## HAWP & Preliminary Consultation MONTGOMERY COUNTY HISTORIC PRESERVATION COMMISSION STAFF REPORT

Address: 7719 Wisconsin Ave., Bethesda Meeting Date: 9/22/2021

**Bethesda Theater** #35/14-04

**Proposal:** Sign Alterations

# Proposed

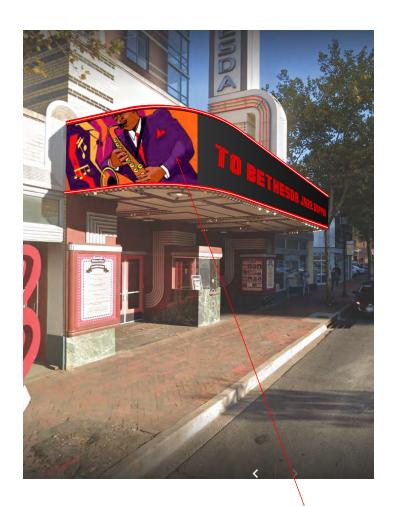
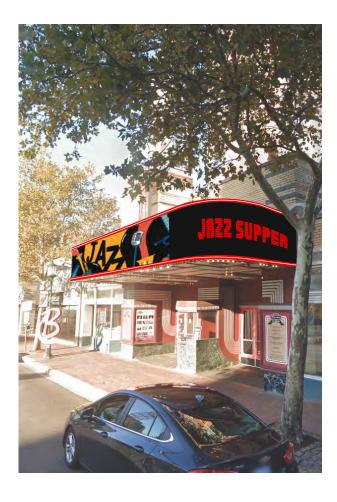
For the HAWP, the applicant proposes removing the existing back-lit marquee and the bands of incandescent light bulbs and install a new LED marquee in matching dimensions. The proposal is similar to the alteration at the Silver Theater (8619 Colesville Road), also designed by John Eberston, as part of the Silver Spring Shopping Center redevelopment project (see below).<sup>1</sup>

Staff finds that the existing marquee has likely reached the end of its lifespan and that many historic theaters, both large and small, have replaced their marquee with LEDs (see above) without detracting from the historic character of the building. Staff also finds that the existing sign has been modified from its original appearance as the Boro Theater (see Fig. 2), so it has lost some of its integrity; both design and materials. A close examination of the photos of the Bethesda theater shows that originally there were two rows of incandescent bulbs at the top and bottom of the marquee. The bulbs were covered or removed while the building operated as the Cinema 'n Drafthouse (see Fig. 5) and were re-introduced in its most recent rehabilitation (Fig 6.).

Staff finds that in a more conservative application of the Standards, the Maryland Historical Trust's Easement Committee also found installing a LED marquee was not out of character with the historic character theater. The Silver Spring Theater sign maintained two bands of incandescent bulbs along the bottom and top of the marquee (see Fig. 4). Staff finds that the same approach should be taken in this instance. The bands of incandescent lights are character defining features and while the marquee can be altered, those bulbs should remain. Staff recommends the HPC approve the HAWP under 24A-8(b)(2), (3), and (6).

Staff recommends that the Commission <u>approve</u> the HAWP application; under the Criteria for Issuance in Chapter 24A-8(b)(2), (3), and (6), having found that the proposal will not substantially alter the exterior features of the historic resource and is compatible in character with the district and the purposes of Chapter 24A;

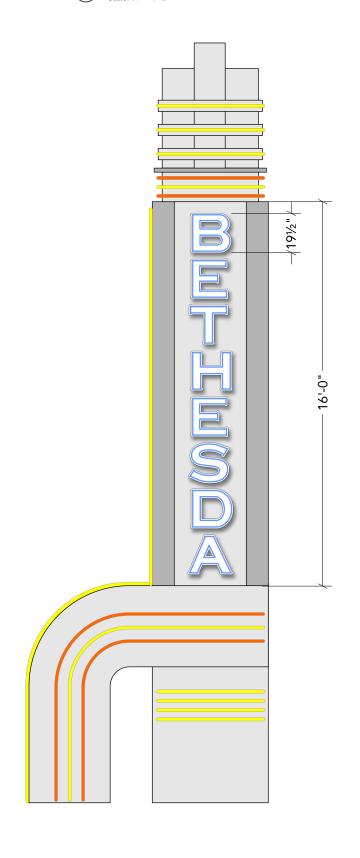
At this time, the applicant only proposes to replace the existing marquee. Sometime in the future, the applicant would like to remove the neon from the "BETHESDA" blade sign and install LED rope lighting in its place. The applicant indicates that the blade sign is experiencing many of the same problems as the marquee, namely, increased maintenance costs and high electric bills as water infiltrates the sign and the wiring degrades with time. In place of the neon tubes, the applicant proposes to install rope LEDs that are designed to be bendable and replicate the appearance of neon lights. Other features and materials of the blade sign will be replaced if they are determined to have significantly deteriorated. The LEDs will run more efficiently than the neon and will have a much longer lifespan.

To Staff's knowledge, this is the first proposed use of these rope LEDs on a designated historic property in the County. The applicant provided examples of the material with the application materials. Based on the sample images, Staff finds that rope LEDs have a similar appearance to neon and it appears to be as flexible as neon tubes, however, Staff does not find that this information provided satisfies the applicant's burden to demonstrate the material is a compatible substitute for the historic. Staff recommends the HPC require the applicant to provide a sample of the material for Staff and the HPC to evaluate in-person either at the Preliminary Consultation or with a HAWP application. The applicant could also identify a location where the rope LEDs have been installed so that Staff and the HPC can evaluate the material in the field.

2) As part of the Preliminary Consultation review instruct the applicant to make revisions based on HPC feedback and return for a HAWP for the neon sign
